AMENDED DEVELOPMENT REVIEW COMMITTEE AGENDA

March 2, 2026

Development Review Committee Staff Report
Meeting Date: March 2, 2026

Review and action on an application for a Preliminary Plan, known as Monument Health, located at 350 E 300 N, American Fork City. The Preliminary Plan consists of approximately 4.85 acres and is in the PO-1 Zone.

SITE AND UTILITY PLAN

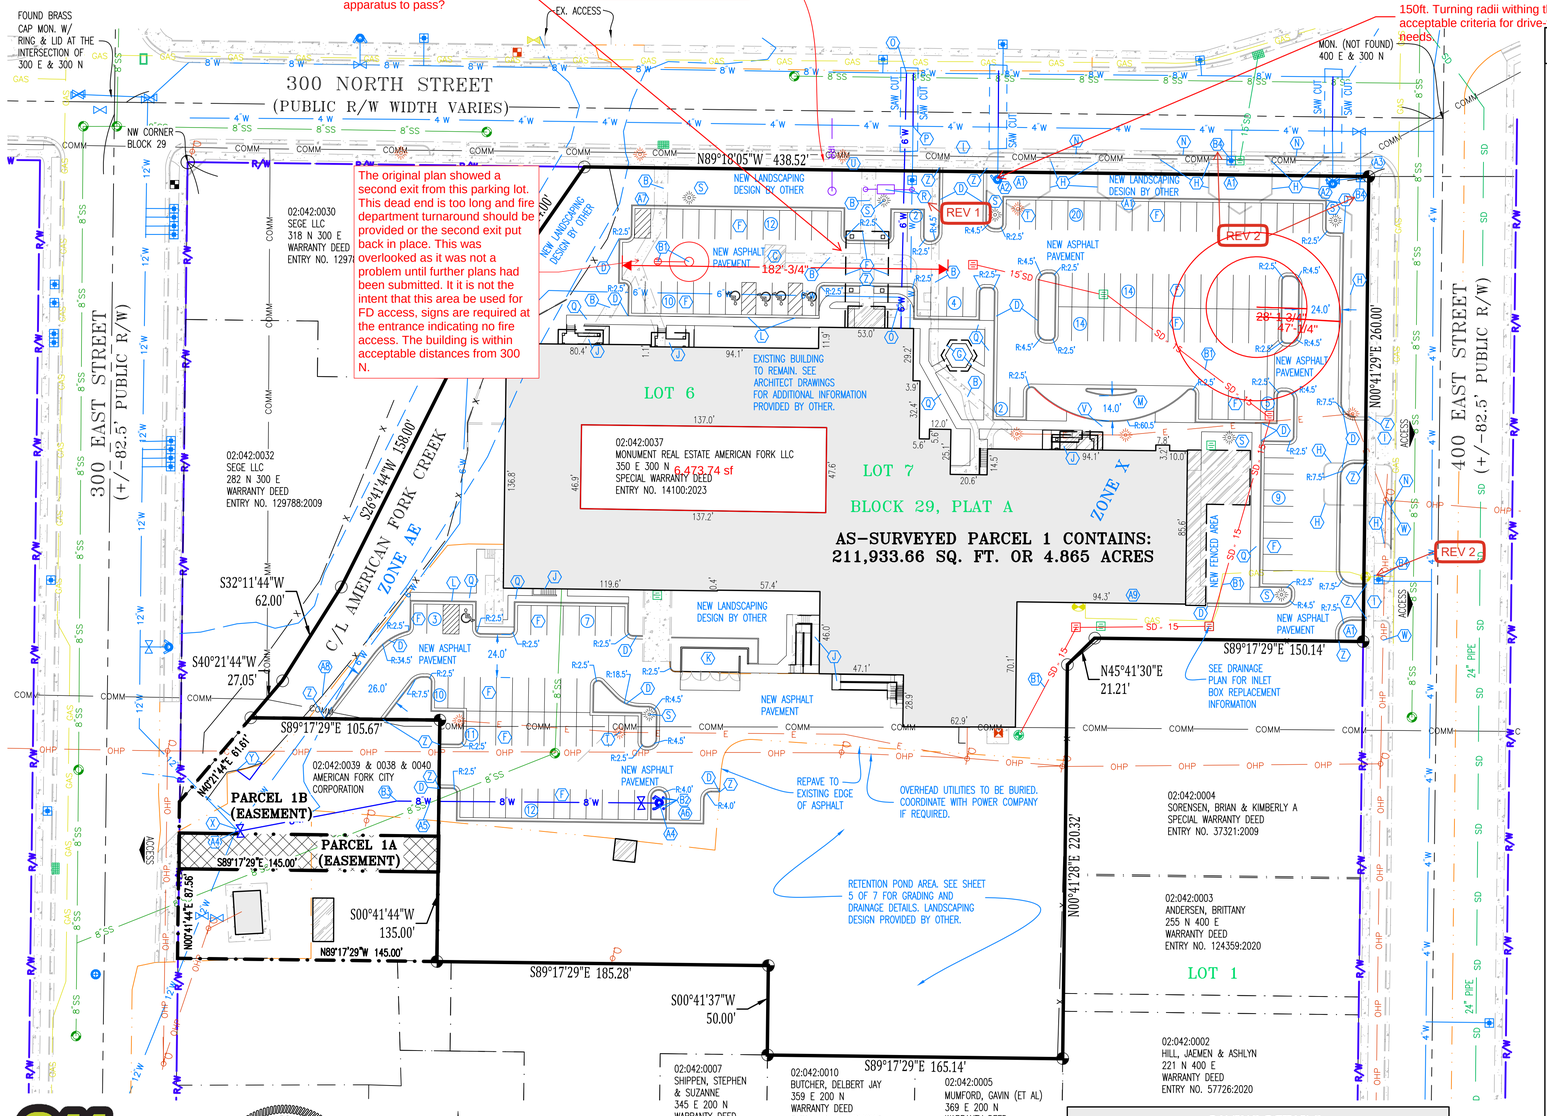
What are the elevations for the porte cochere? Will this be tall enough for ambulance or fire apparatus to pass?

The original plan showed a second exit from this parking lot. This dead end is too long and fire department turnaround should be provided or the second exit put back in place. This was overlooked as it was not a problem until further plans had been submitted. It it is not the intent that this area be used for FD access, signs are required at the entrance indicating no fire access. The building is within acceptable distances from 300 N.
